LAND AT CINDERS LANE
YAPTON

PROPOSED SITE ACCESS

STAGE 1 ROAD SAFETY AUDIT

DECEMBER 2016

LOCATION: Proposed access

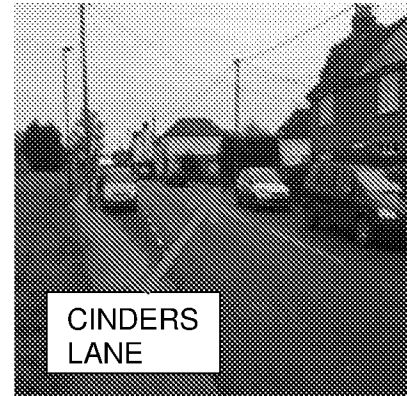
SUMMARY: Compromised visibility

At the time of the site visit parked vehicles were present either side of Cinders Lane. These vehicles would compromise the visibility from the development should they remain which could lead to vehicles turning from the Cinders Lane in front of through traffic resulting in collisions.

Ensure visibility splays are not compromised by parked vehicles.

Problem no. in safety audit report	Problem accepted (yes/no)	Recommended measure accepted (yes/no)	Alternative measure (detail description)
3.1	Y	N	Use all 'reasonable endeavours' to secure a TRO prohibiting parking on Bilsham Road for the extent of the visibility splays, during the day (such as 8am to 6pm) when the majority of vehicles movements generated by the proposed development would occur.
